# DESIGN COMPLIANCE REVIEW

## ACCESS

### 11-17 Columbia Lane Homebush

**Report Prepared for:** JQZ Group Pty Ltd.  
**Report Prepared by:** Doug Melloh  
**Our Ref:** AN19-213033  
**Date:** 09 August 2019

drawing title Adaptable & Livable Units

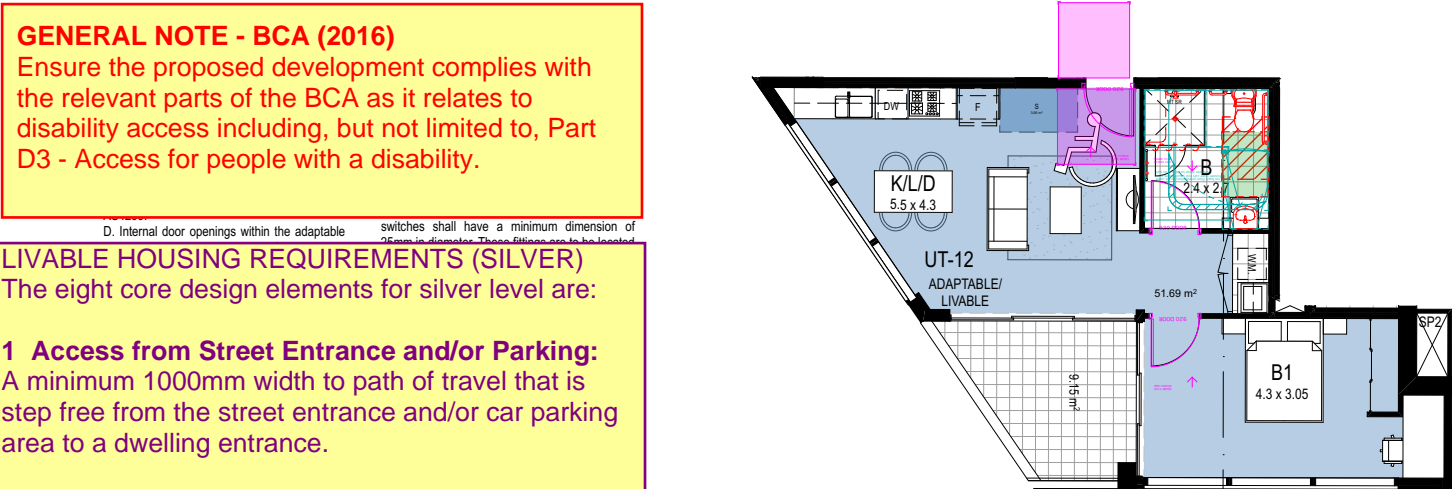
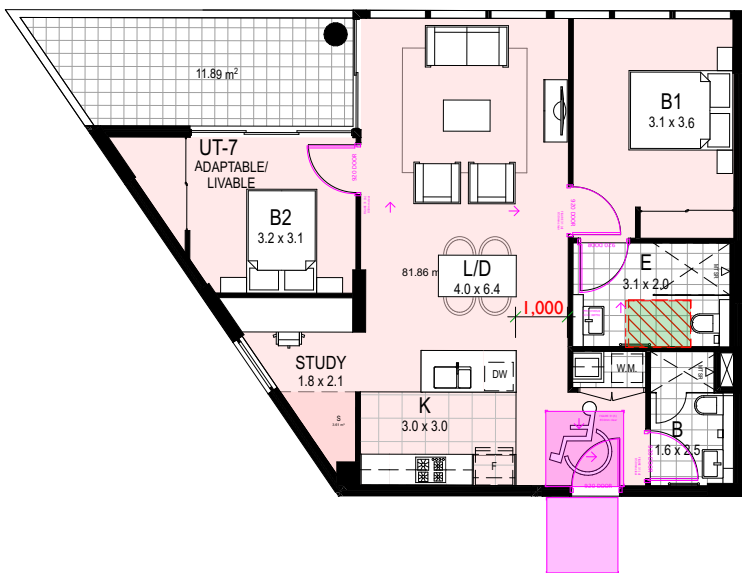
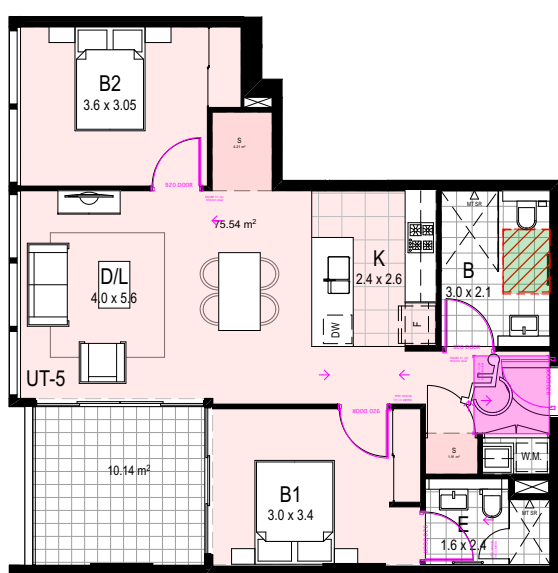
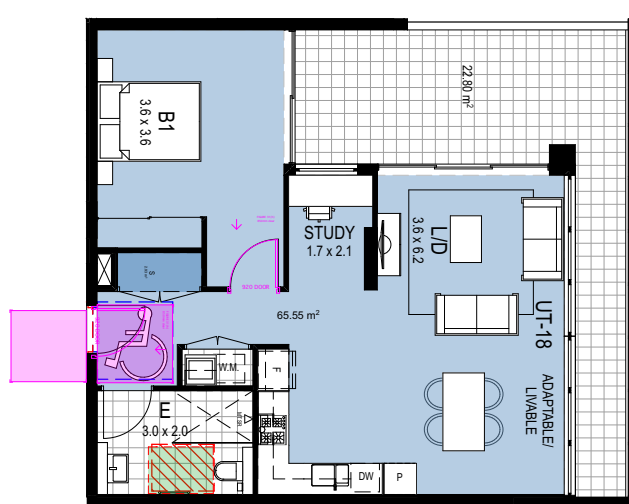
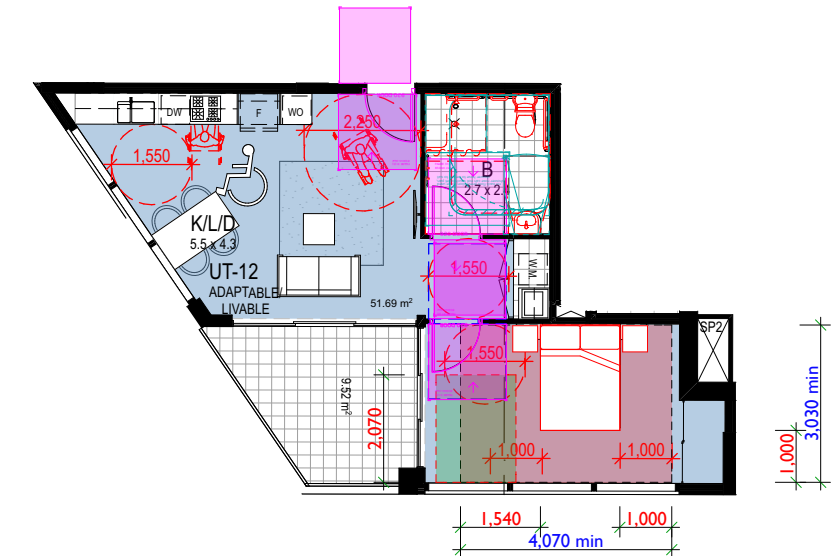
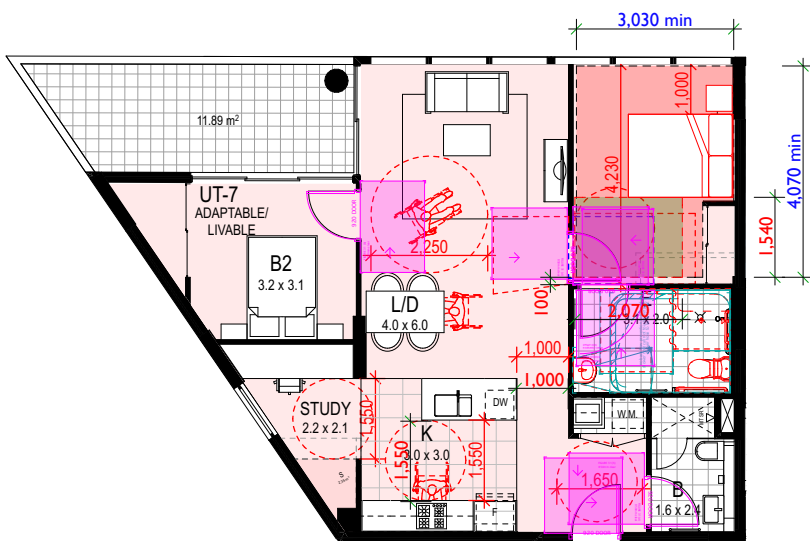
- 4 Easy Access Toilet:**
  - a) Provide a toilet on the ground or entry level with a minimum of 900 x 1200mm circulation space in front of toilet pan and clear of door swing.

- 7 Internal Stairway:**  
Provide a continuous handrail on one side of any stairway where there is a rise of more than one metre.

4. On an accessway where there is no chair rail, handrail or transom, all fire-rated or fully glazed doors, sidelights or glazing capable of being mistaken for a doorway or opening will be clearly marked and comply with Clause 6.6 of AS1428.1-2009. A solid non-transparent contrasting line not less than 75mm wide is to extend across the full width of the glazing panel. The lower edge of the contrasting line is to be located between 900mm and 1000mm above the plane of the finished floor level. The contrasting line is to provide a minimum of 30% luminance contrast when viewed against the floor surface or surfaces within 2 metres of the glazing on the opposite side.

49. Provision for the toilet to comply with AS1428.1 will be provided, including locating the pan in the correct position or providing future plumbing correction, and the provision for the installation of all grabrails in accordance with Clauses 4.4.1, 4.4.3 and 4.4.4(h) of AS4299.
